CMB Meeting Minutes #142

REFERENCE Project No. M544.1, Contract No. 149 Task 1-8.02

SUBJECT: Configuration Management Board Meeting # 142 – Rev. No. 0

\\sv6nas003\m5444.1\finaldesign\DRAWINGS\CS155-2\1254\sheet files\02_CIVIL\06_joint trench\12540206JT203_R1.dwg aschrode Wed Aug 15.2012 4:03 pm JT-203

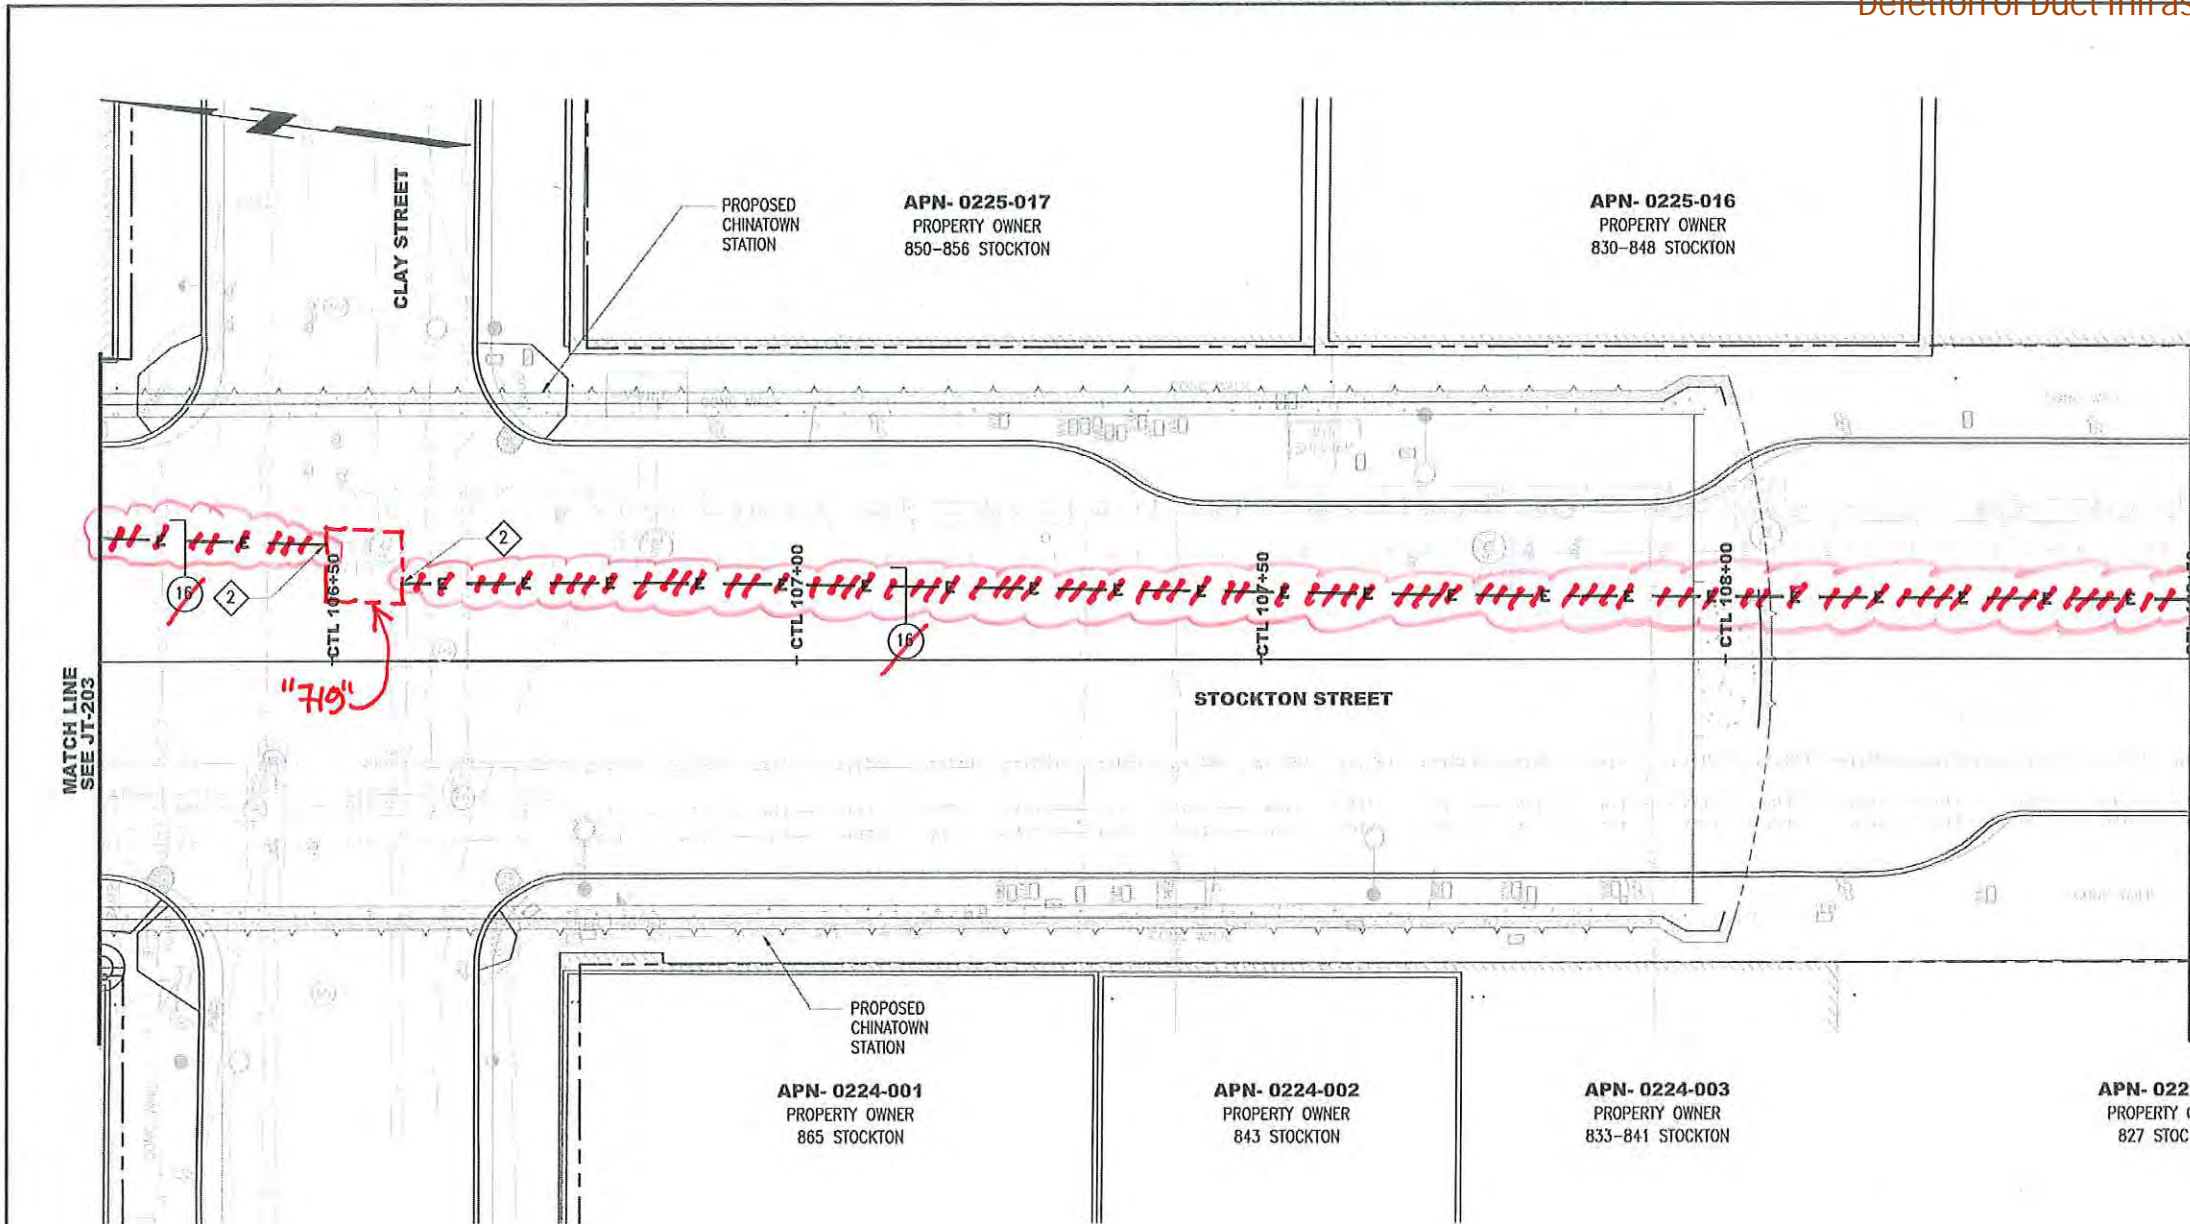
- Delete approximately 510 lf of duct bank consisting of 3-6" conduits for PG&E
- Delete approximately 35 lf of duct bank consisting of 3-6" conduits for PG&E
- Delete related trenching associated with duct bank
- Delete backfill of trench
- Delete pavement restoration
- Delete Traffic Control for this work

Recommended Action: Delete the duct bank (described as Conduit Note 16) as shown on sheets JT-203 Rev. 1, JT-204, JT-205

UTILITY COMPOSITE
CTL 106+25 TO 108+50

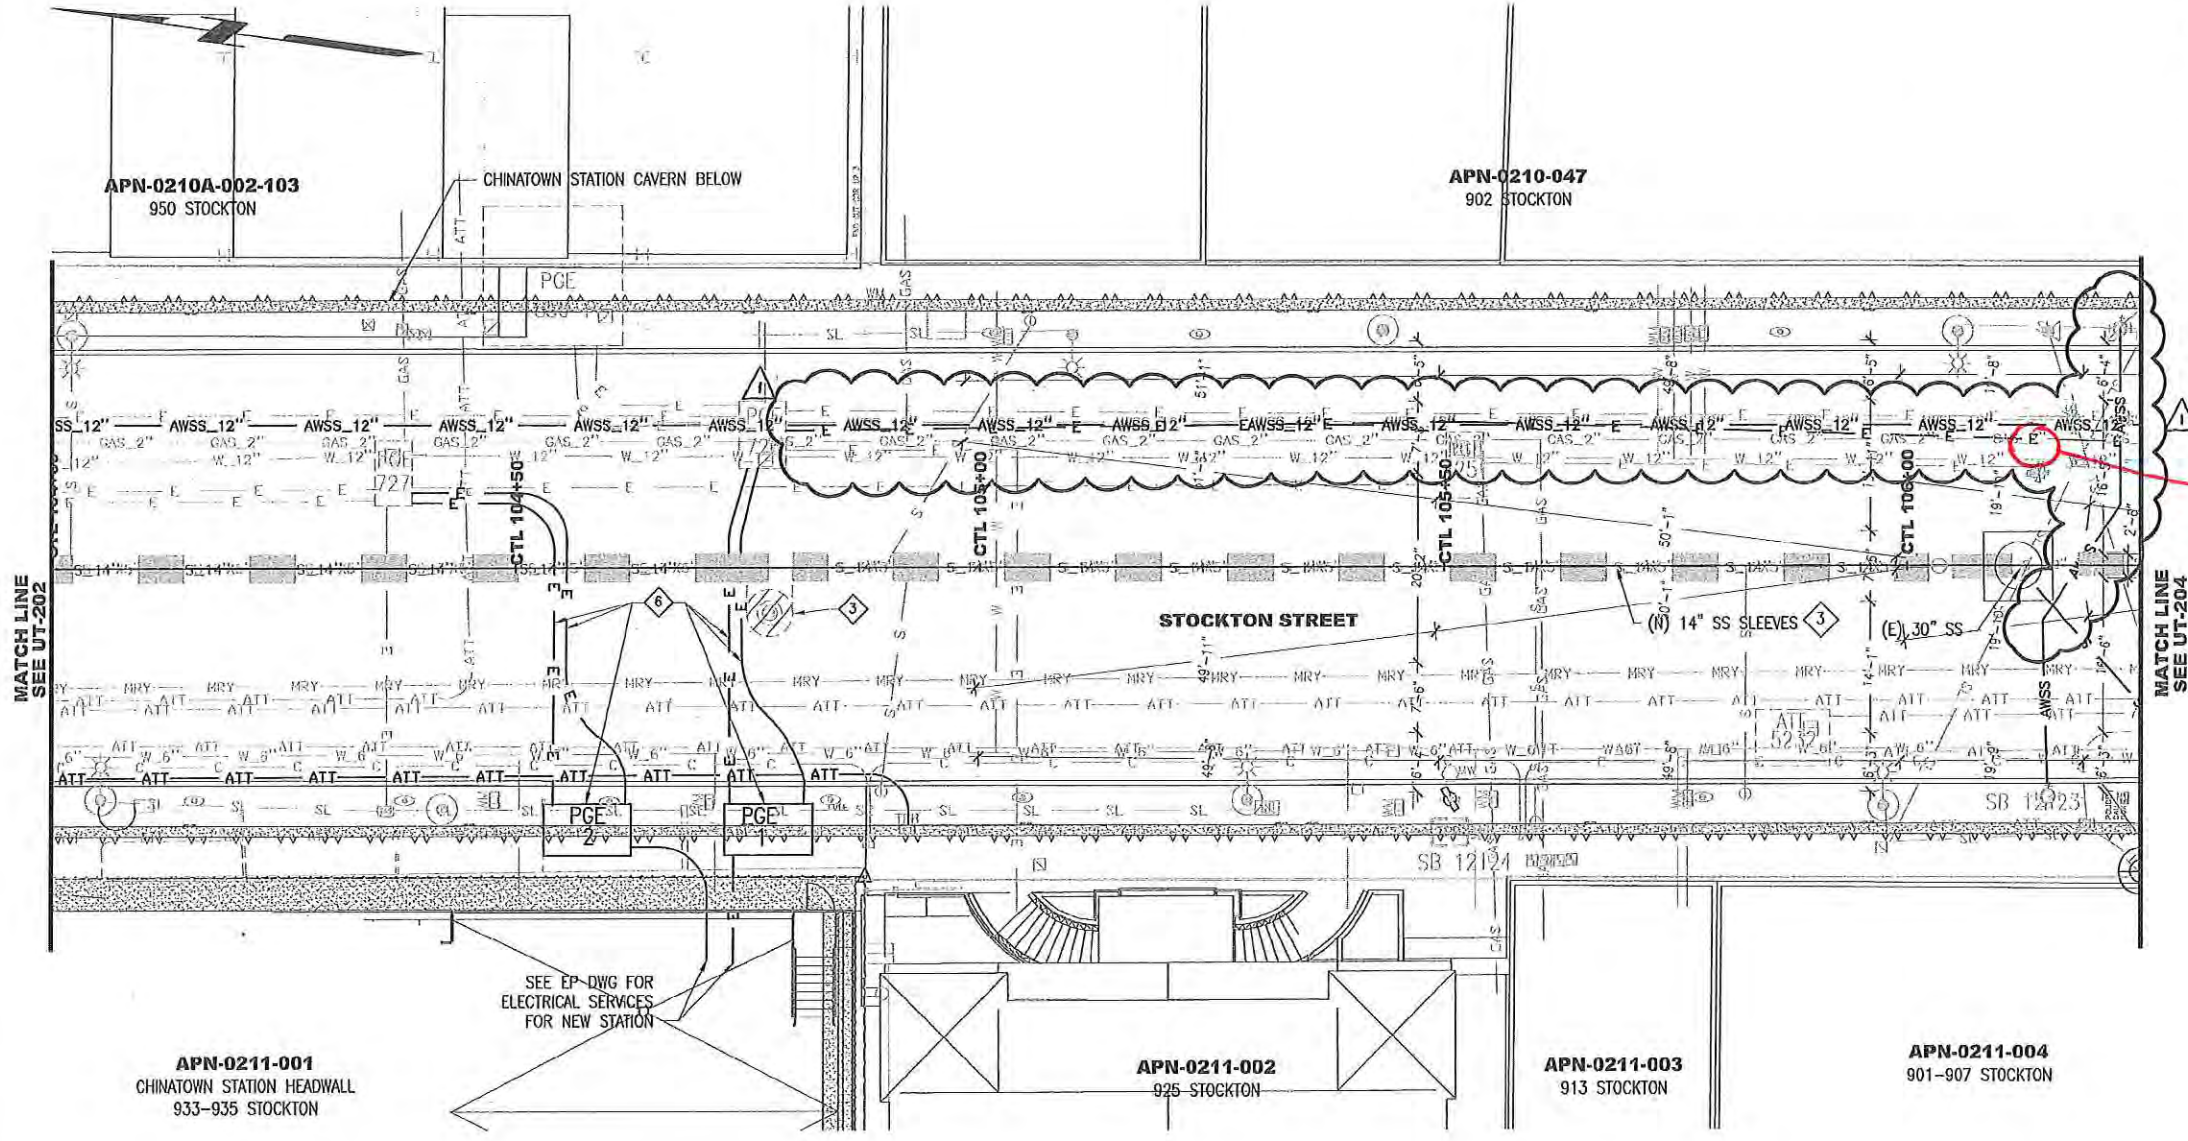
Drawing Nos.: 1254R CTS JT-203 Rev. 1, JT-204, JT-205, also shown on UT-203 Rev. 1, UT-204 Rev.1

SKME DELETION
SHOWN ON
DWG. JT. 204 r0
